GZA
GeoEnvironmental, Inc.

Re: Task 3 Dam Assessment - Final Report
Project #0-381
SRP Coronado Generating Station Evaporation Pond Dam
Apache County, Arizona

Evaporation Pond Dam
Salt River Project - Coronado Generating Station

FINAL REPORT

FIGURE 8

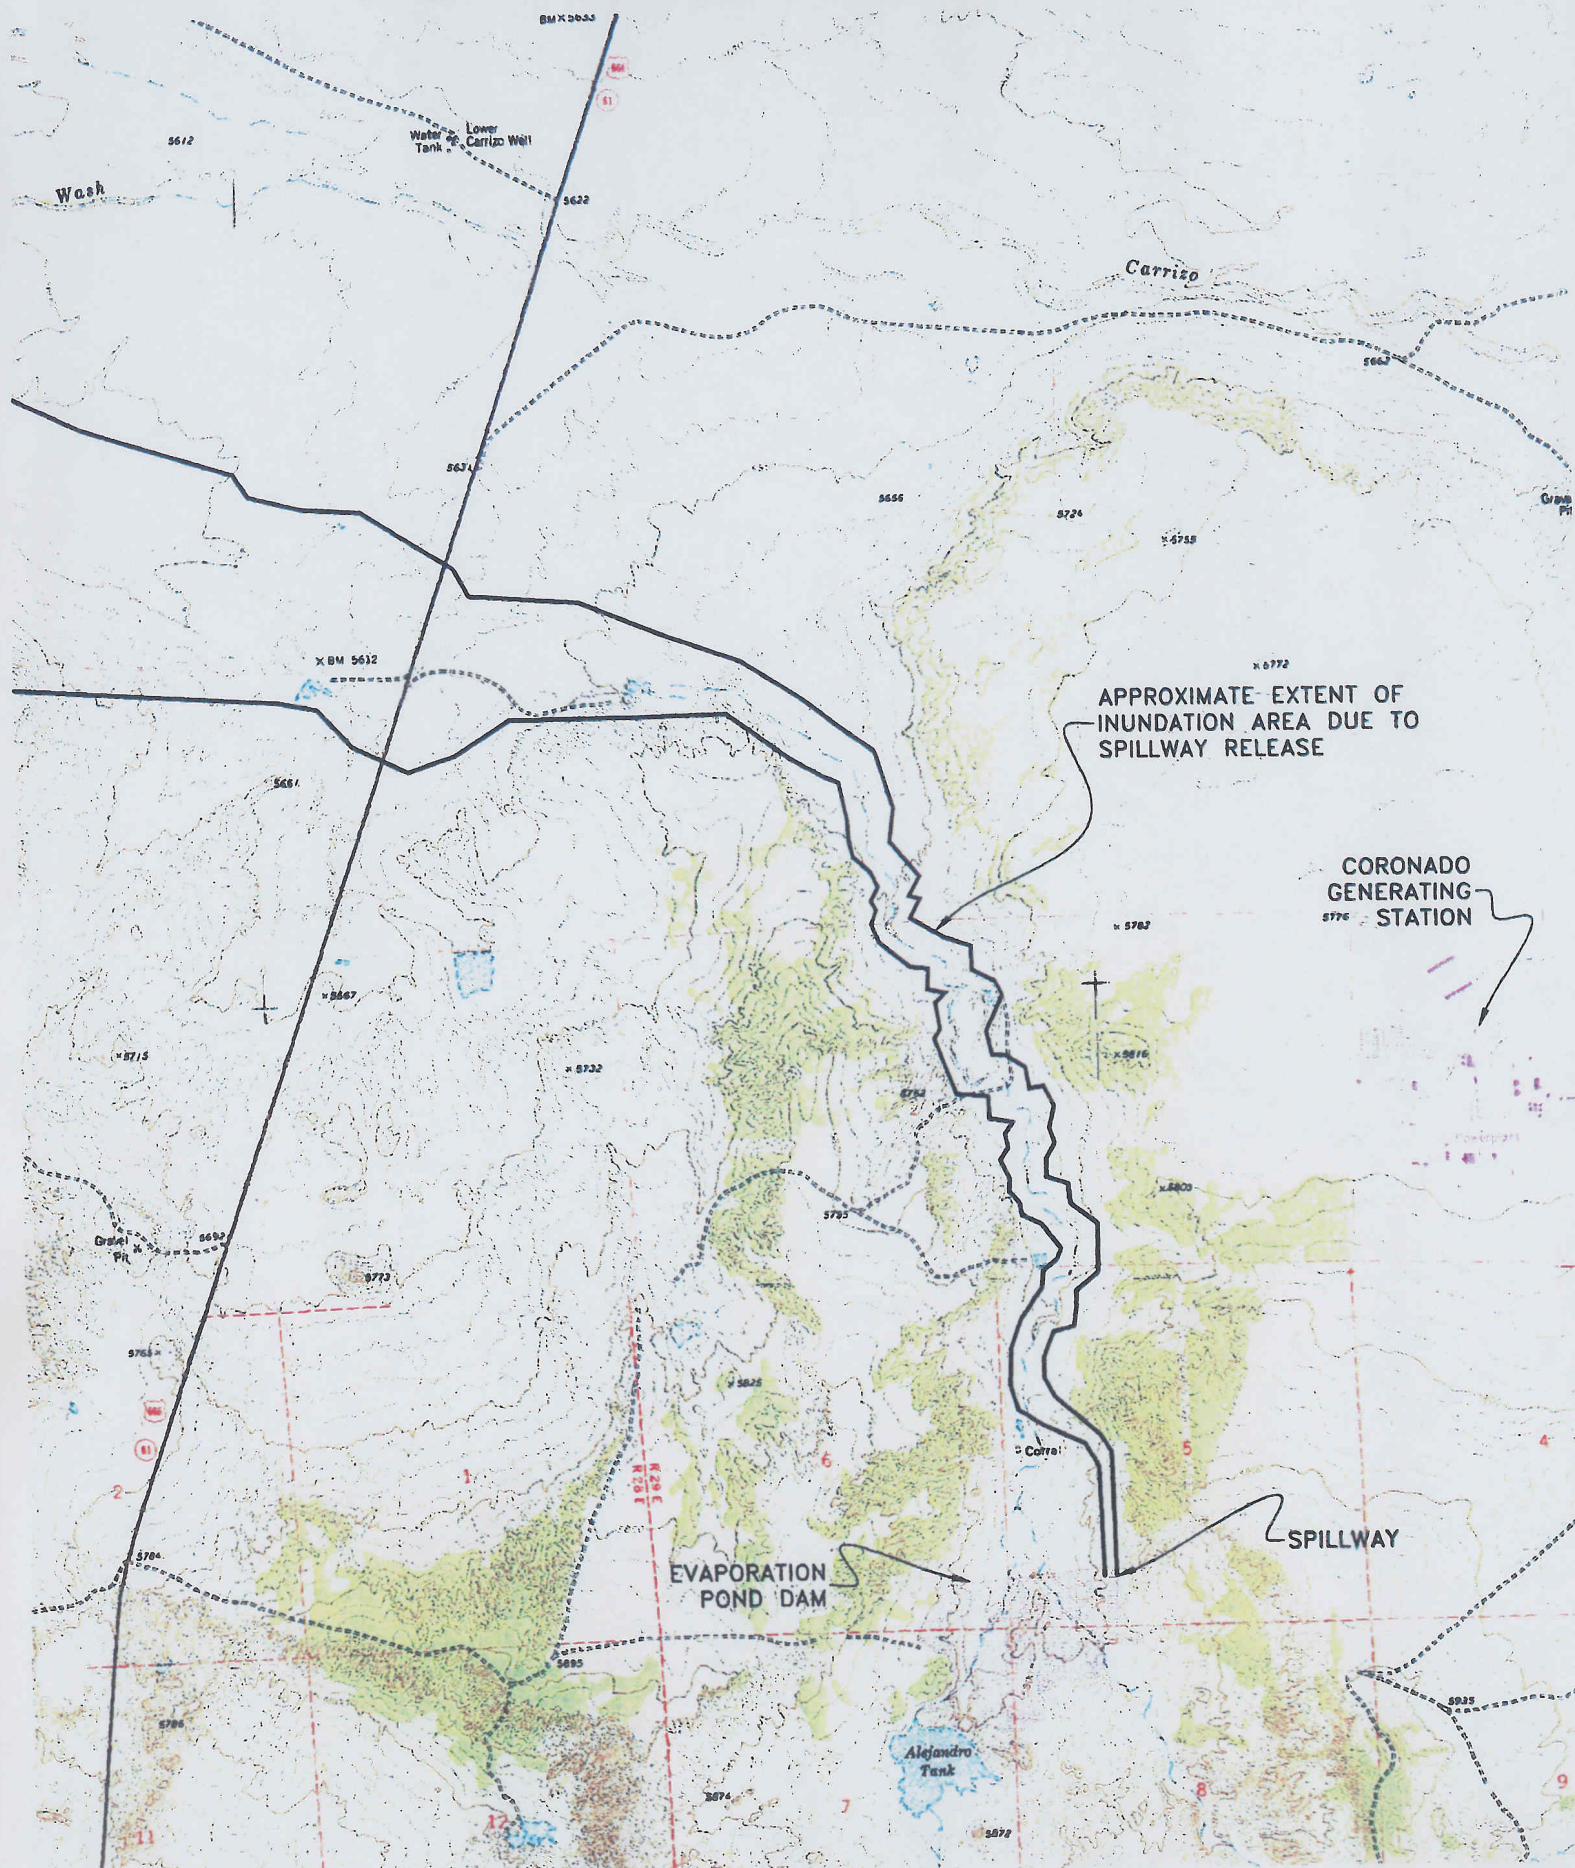
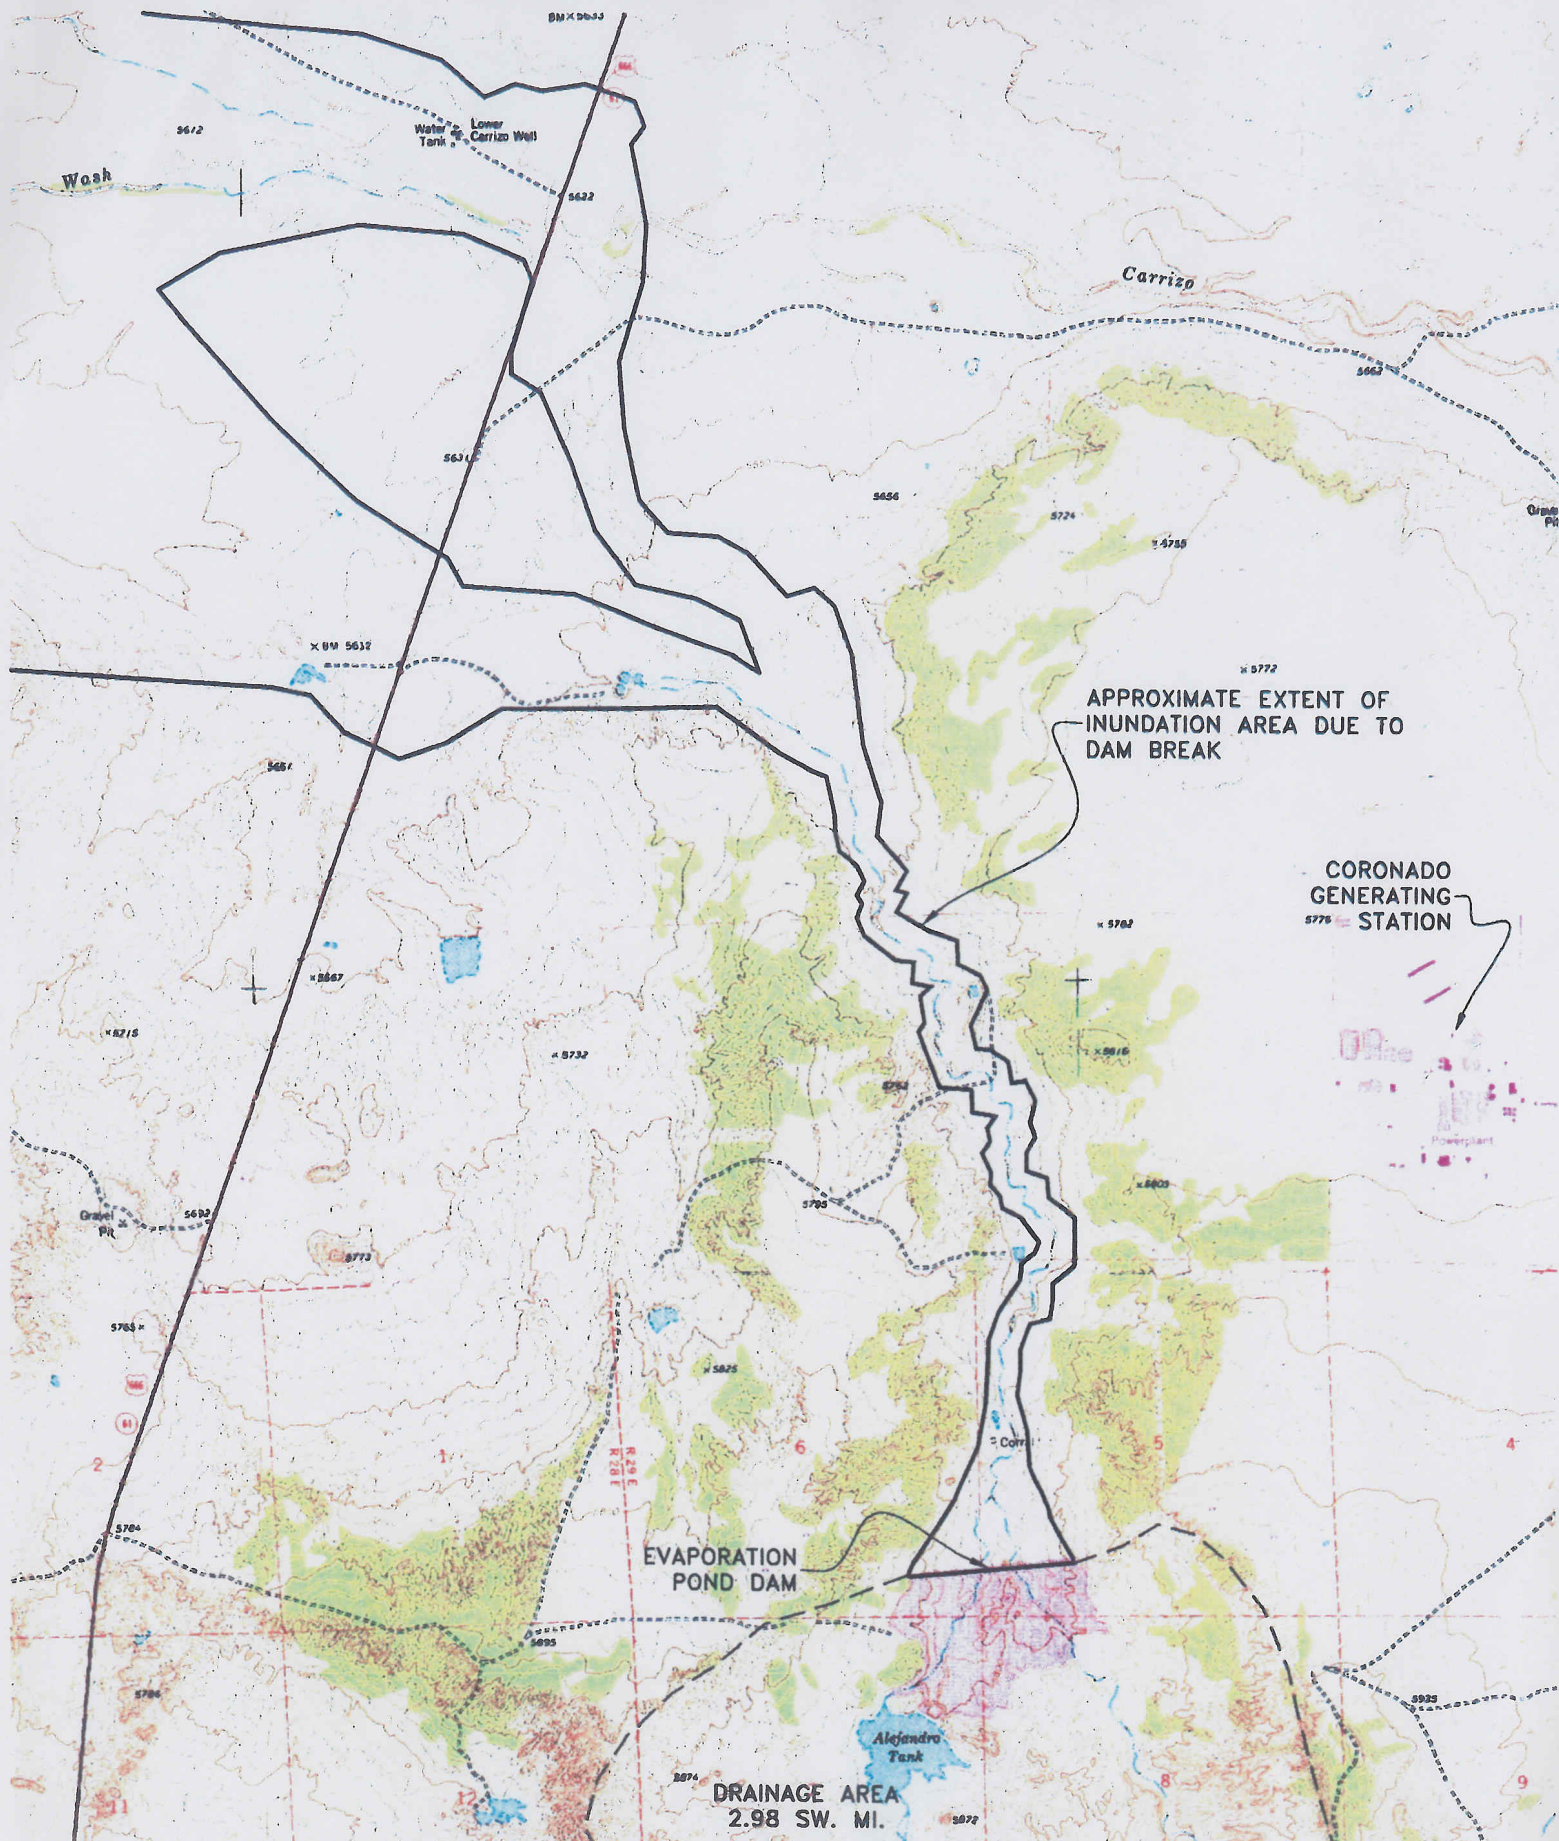
1. Page 17, Emergency Warning System. Recommend that title of this section be changed to "Emergency Action Plan."
2. Page 17, Emergency Warning System. Check figure references. The referenced figures should be Figures 8 and 9, and not Figures 7 and 8, as listed.
3. Page 17, Emergency Warning System. Recommend adding discussion on Hazard Potential Rating and/or reference discussion found at Page 7, Section 1.2.7. Hazard Potential Classification. Also, GZA Environmental, Inc. (GZA) should include any calculations performed by GZA to verify inundation information. What is the inundation depth at the Access Road?

1. GZA has changed the title of the “Emergency Warning System” section to “Emergency Action Plan”, as suggested.
2. GZA has updated the Figure references as noted.

3. GZA has referenced the “Hazard Potential Classification” section of the report. GZA did not perform calculations to independently verify the inundation areas presented in the Emergency Action Plan (Figures 8 and 9). Regarding the inundation depth at the Access Road, the Emergency Action Plan did not contain detailed hydraulic information regarding downstream flow rates and flow depths. For the purposes of an Emergency Action Plan, in the event of a dam failure, the conservative assumption is typically made that downstream roadway culverts will be blocked by debris and/or sediment carried downstream by a potential flood wave, and that small roadway embankments will be damaged by overtopping flow. In GZA’s opinion, roadway closures at the Access Road and U.S. Highway 191 are appropriate given an actual or potential emergency situation at the Evaporation Pond Dam.
